NUMBER: 84-23

## LEAKING EXHAUST PIPE ON MCM 120MR and 140MR

**Figure 1. Lower Exhaust Pipe Water Leakage**

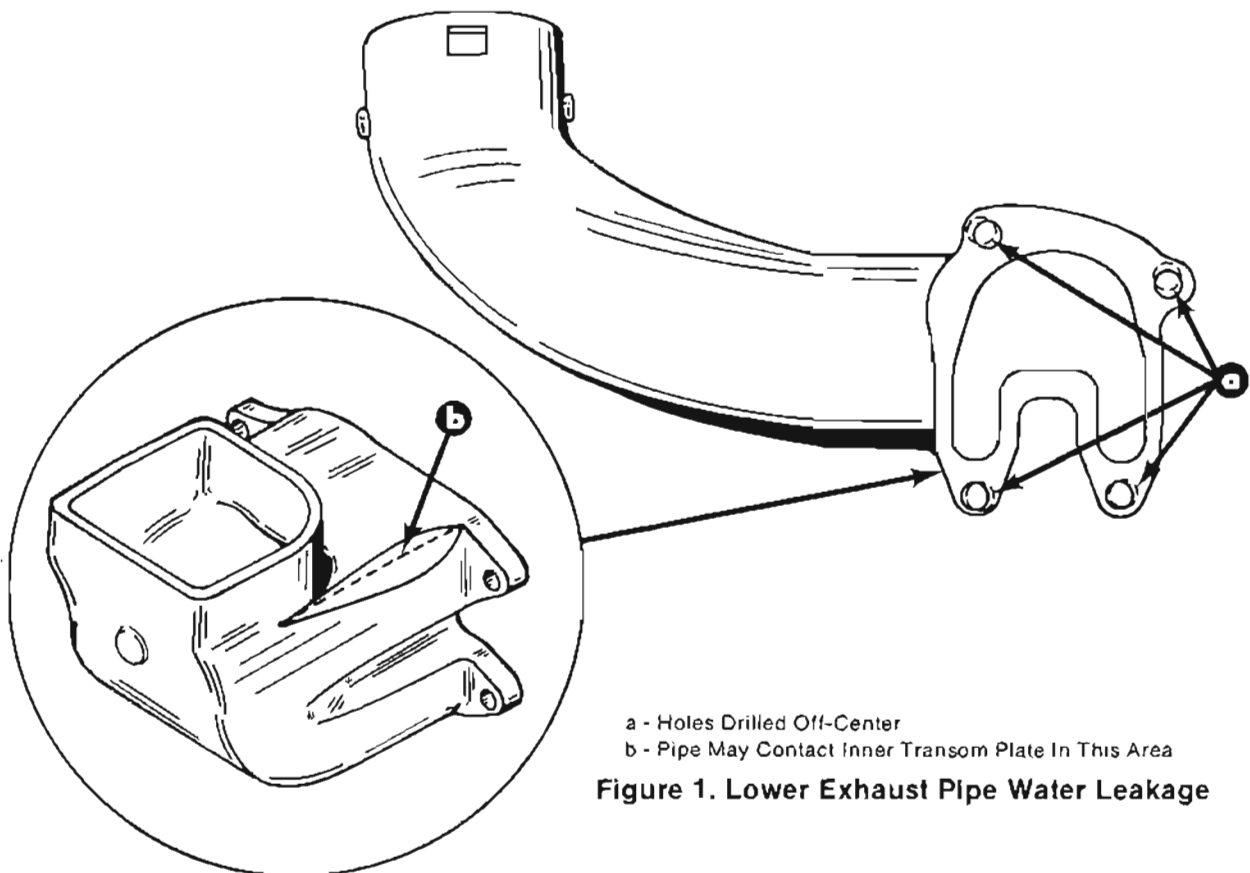
MerCruiser 120MR and 140MR power packages with engine serial number 6865151 to 6876739 may be subject to a water leak at the lower exhaust pipe. The problem could be caused by one or both of the following conditions: (Figure 1)

1. Mounting holes in exhaust pipe may be drilled off-center. This could cock the exhaust pipe and prevent it from sealing properly against the seal on the gimbal housing.
2. Exhaust pipe may be contacting inner transom plate, preventing it from butting squarely against gimbal housing mounting surface.

If you encounter a power package with either of the above conditions, install new, lower exhaust pipe, 42421A5. Labor allowance is 3.5 hours.
